1st Further Information

**Proposed Temporary Open Storage of Construction Materials and Machinery
and Associated Filling of Land for a Period of 3 Years in "Agriculture" Zone,
Lots 36, 37 (Part) and 38 (Part) in D.D. 38, Man Uk Pin, New Territories**

(S.16 Planning Application No. A/NE-MUP/231)

Response-to-Comment (RtC)

Revised plan showing the Filling of Land at the Site

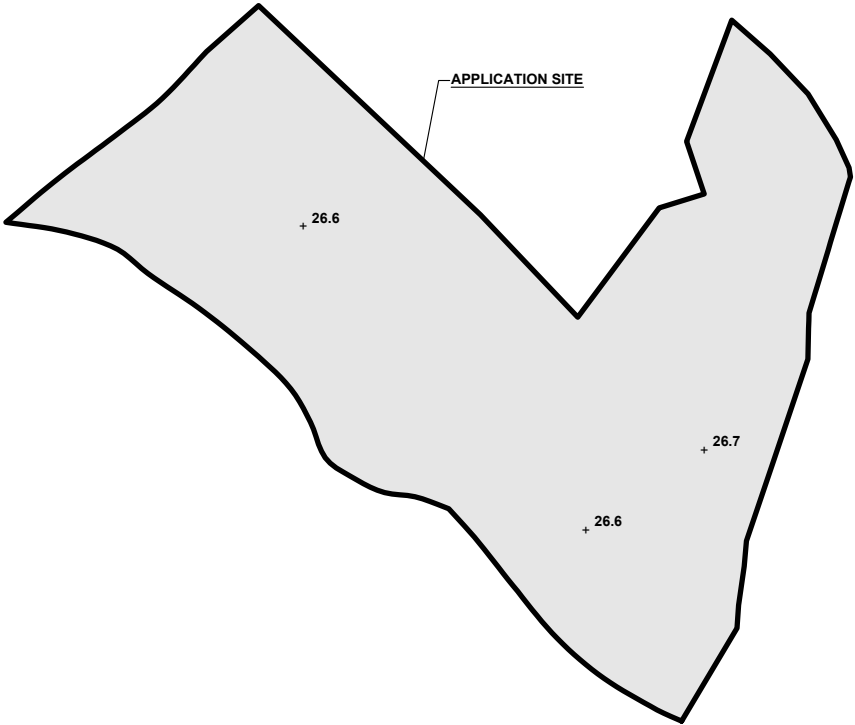
(a)	Please clarify the current site level and surface condition.	Majority of the Site is currently hard-paved, while the remaining area is covered by soil. The current site level and surface condition are reflected at the revised plan showing the filling of land area at the Site (Annex 1). The Site is proposed to be hard-paved wholly with concrete of not more than 0.2 m in depth for open storage area, and vehicle parking, L/UL and circulation area (Annex 1). Upon completion of the proposed filling of land, the site levels will range between +26.6 mPD and +26.7 mPD.

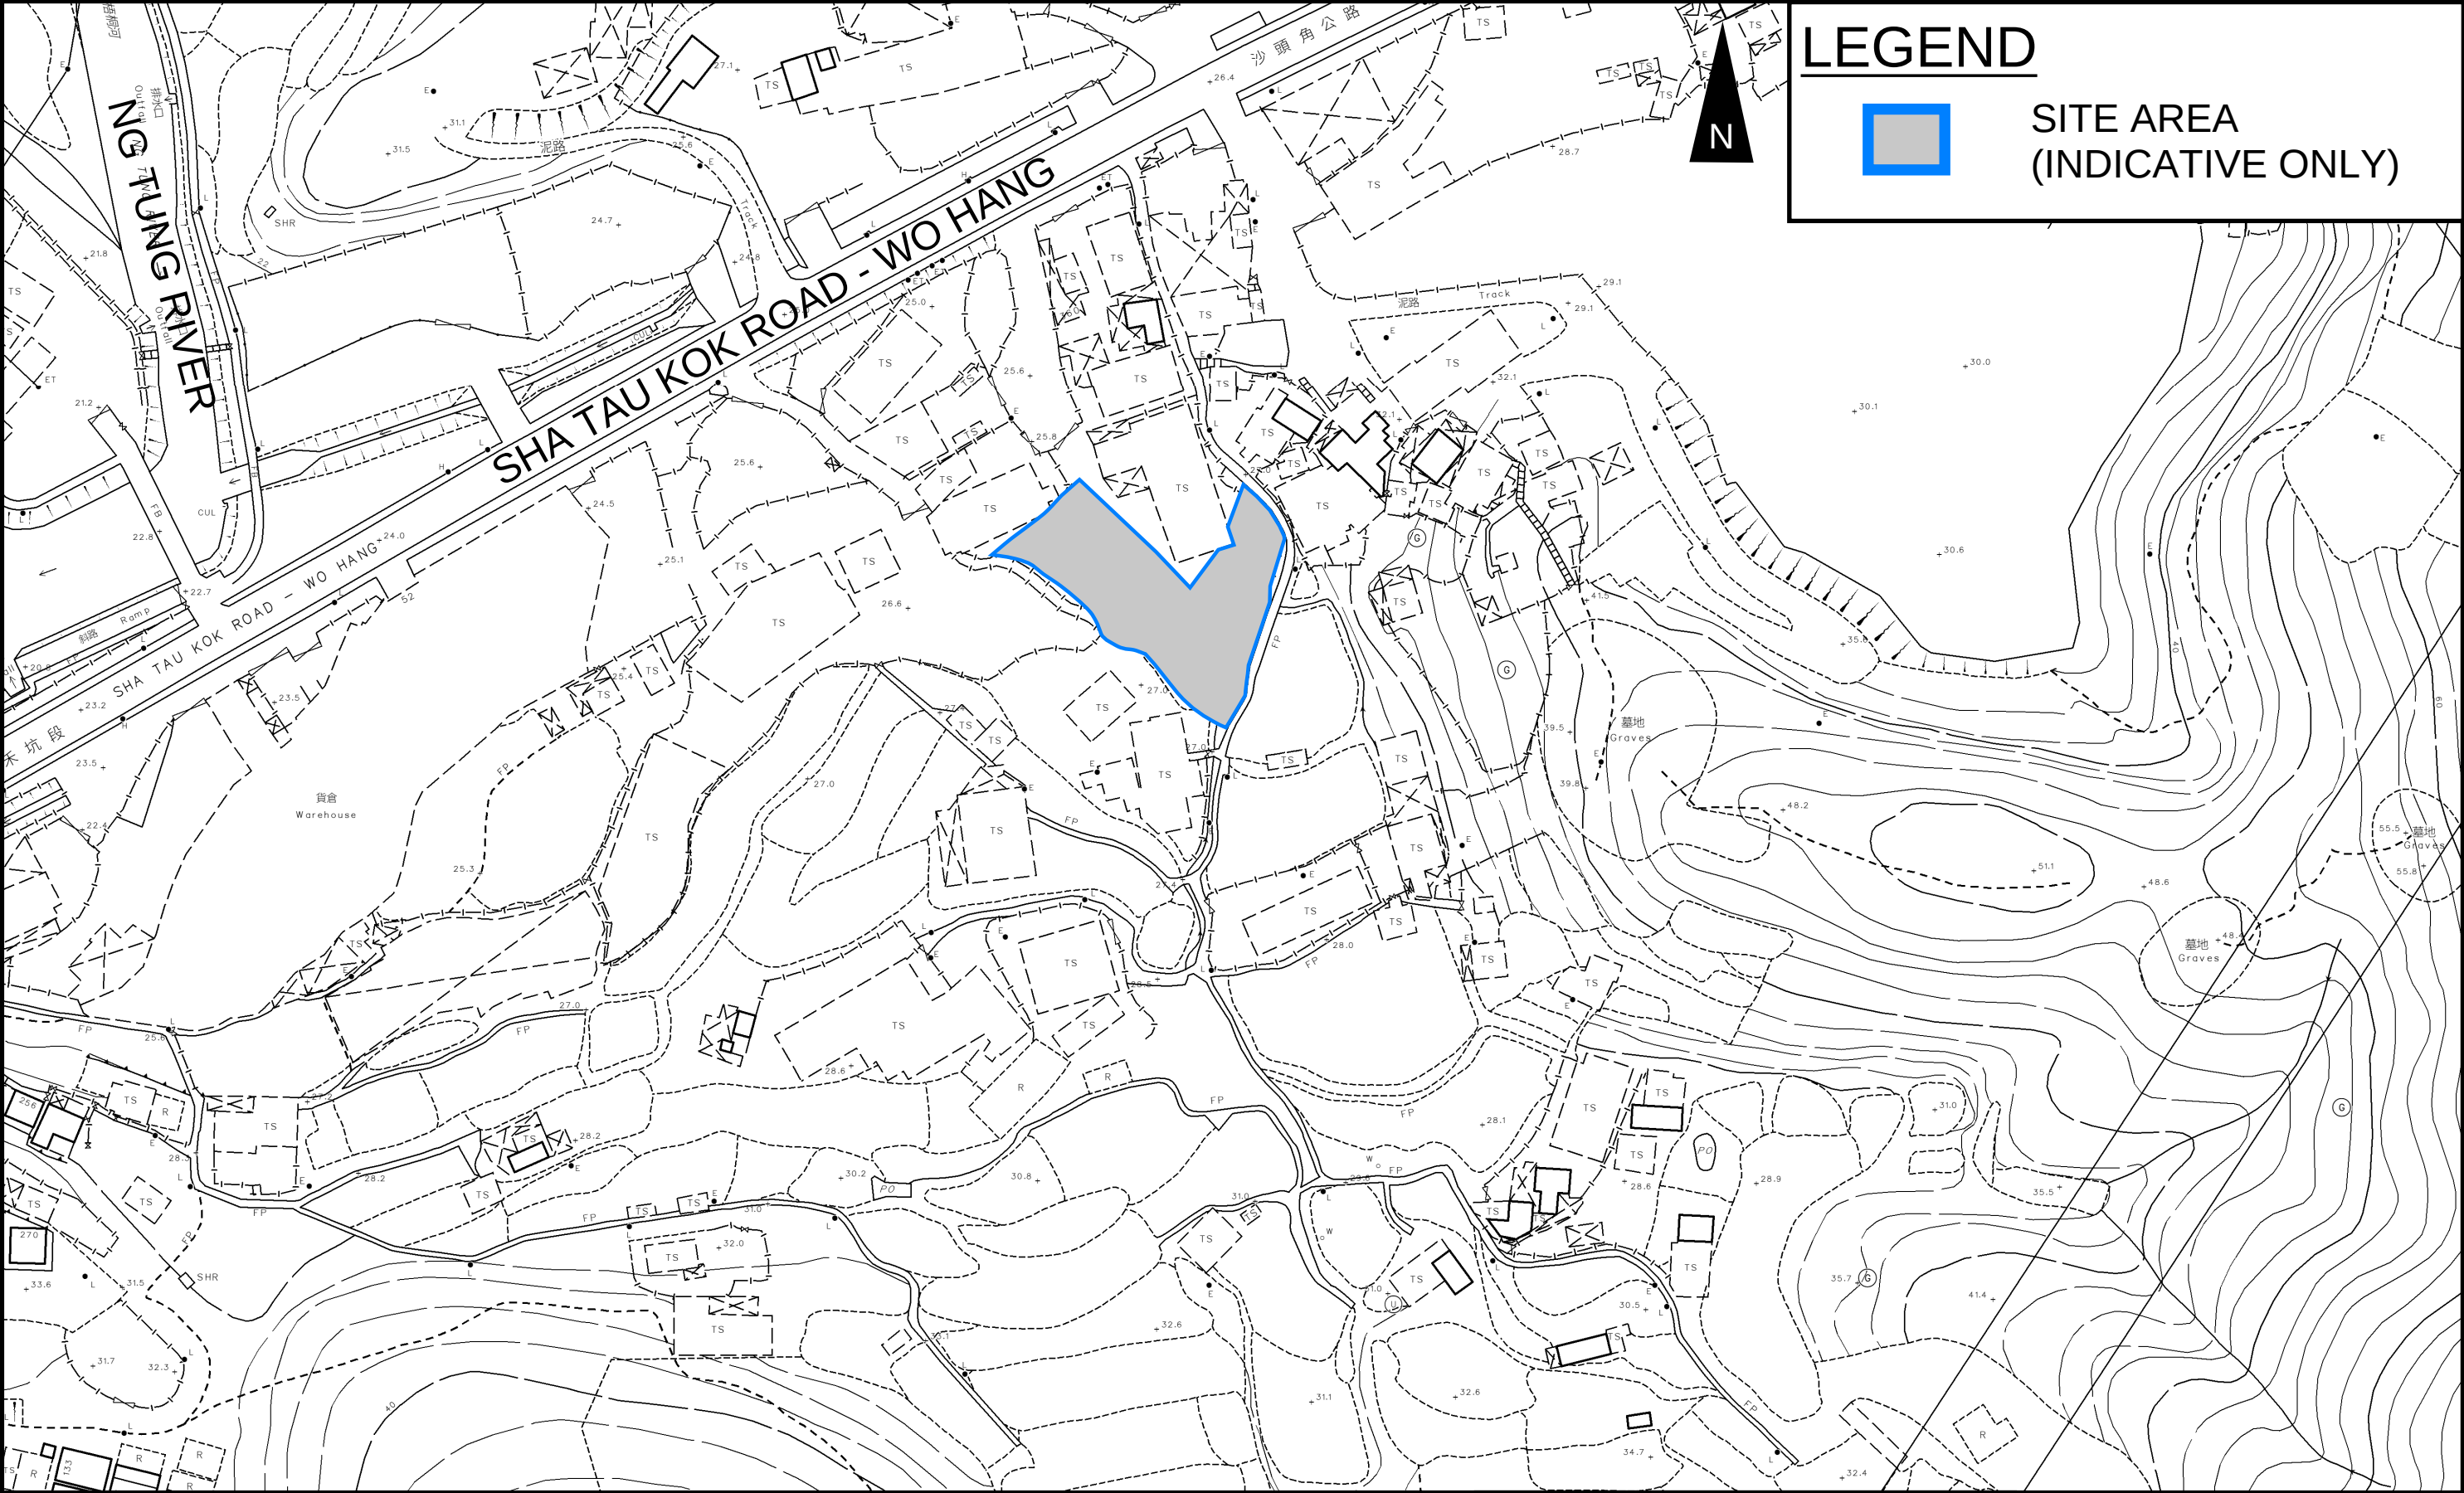
(n)	<u>Specific Comments</u> Section 1.2.3: the applicant should supplement details of the existing watercourses (e.g. dimension, gradient, invert level etc.), and site photos showing the condition of the watercourses;	Noted. Please find supplement details of existing watercourse in Figure 3 for your perusal. Photos are shown in Appendix D of Annex 2 .

(o)	Figure 3 refers: (i) the alignment of drainage facilities between CP2.01 to CP2.05 is unclear. The applicant should review the scale of this figure; (ii) detail A: the applicant should indicate the details of drainage facilities connecting the inlet structures and the catch pits (e.g. type, dimension, gradient, invert level, etc.). Invert levels of the existing watercourse and the inlet structures should also be indicated. Section of detail A should be supplemented; (iii) catchpit should be provided at each location of a change of flow direction of the proposed u-channel; (iv) thickness of concrete cover/grating should be considered when determining the invert levels of catch pits and u-channels to ensure the depths of u-channels are adequate. For instance, the depth of UC at SP01 is less than 375mm; (v) drainage schedule: there are 2 inlets at CP1.01 and CP1.02. The applicant should indicate the invert levels of both inlets in the schedule; and	Noted. Figure 3 is updated for your perusal. Please kindly note the details of existing watercourse are updated in Figure 3. The existing watercourse are proposed to be maintained. The proposed drains would be connected to existing watercourse at CP1.03 only. Noted. Catchpits are provided at each turning point. Noted. Channel cover thickness is considered in updated drainage schedule and Appendix A of Annex 2. Please kindly note the drainage arrangement is revised. The existing drains are surrounding the site at eastern and southern boundary. The existing drains are proposed to be maintained. The proposed drains would be connected to existing drains at CP1.03 only.

FIGURE NUMBER
FIGURE 4

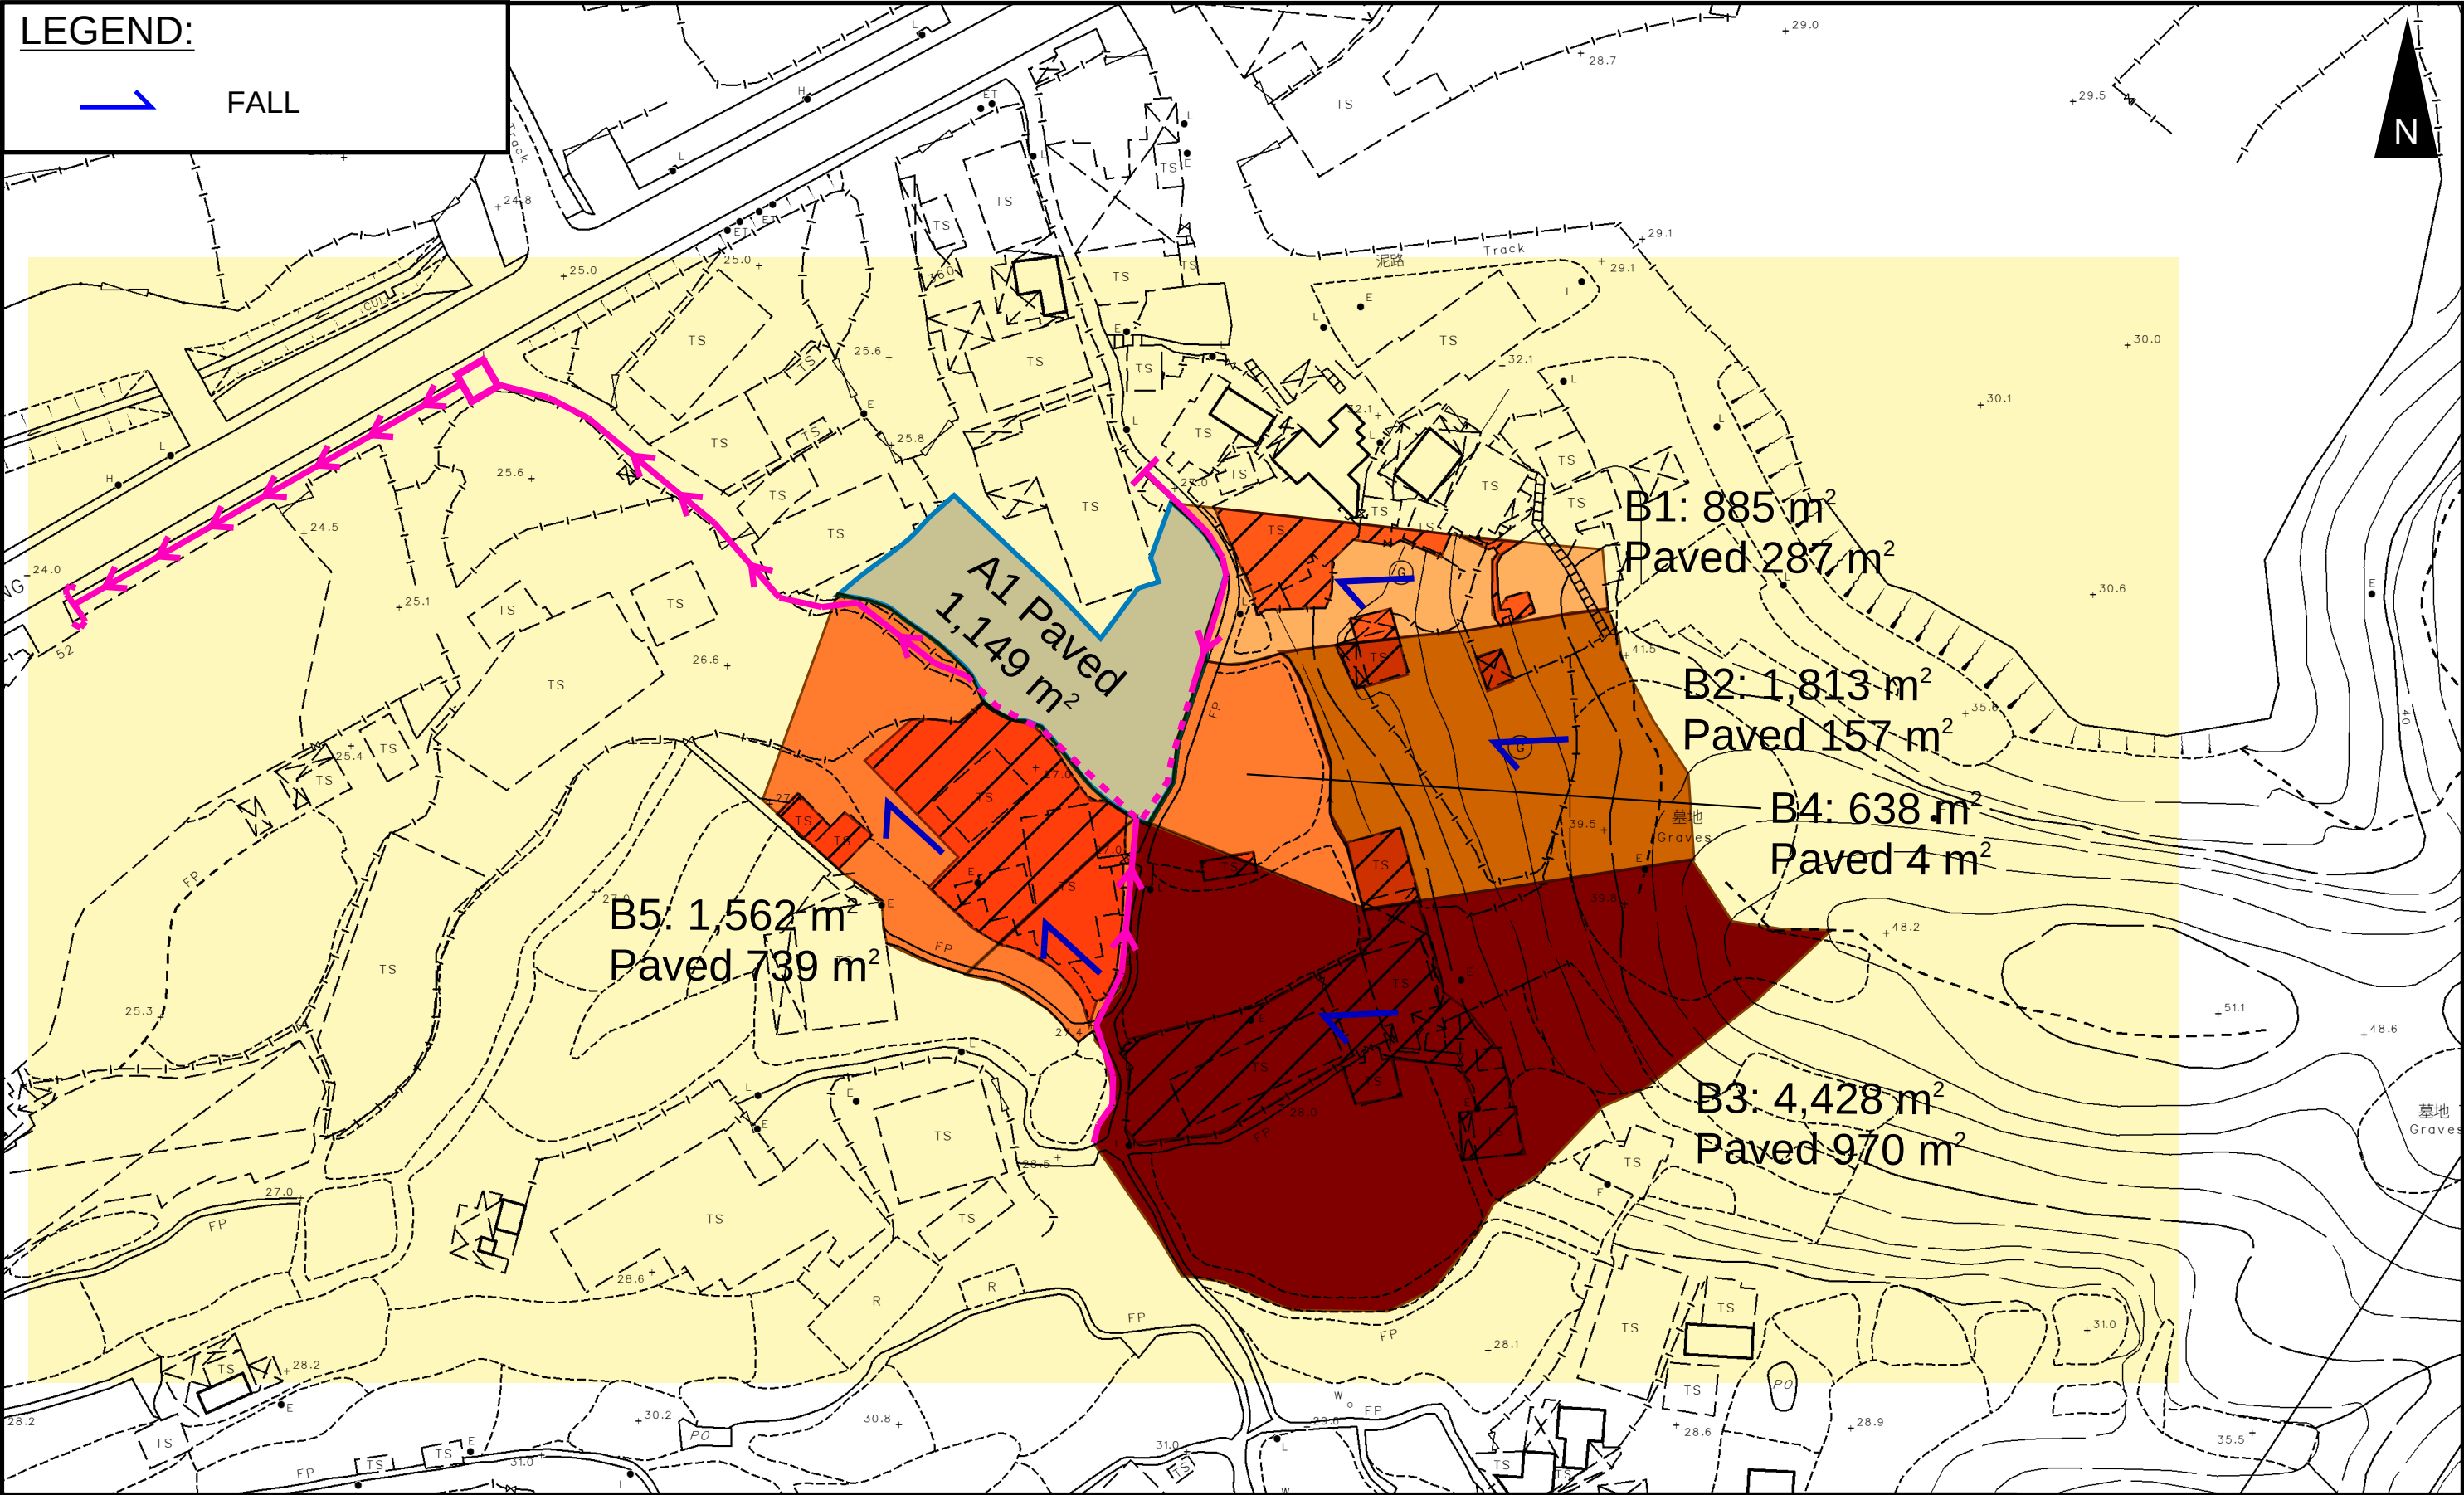
(vi) the applicant should indicate whether grating/cover will be provided for the proposed UC;	Noted. Covers are to be provided for the proposed UC.
(p)	Figure 4: the surface runoff collected by the UC connecting CP1.03 and the existing manhole should be considered; and	Please kindly note the drainage arrangement is revised. Existing 700mm underground pipe is proposed to be used to connect to the existing 900mm channel at Sha Tau Kok Road.
(q)	the applicant should supplement typical details of catch pit without trap.	Noted. Appendix C of Annex 2 is updated for your perusal.
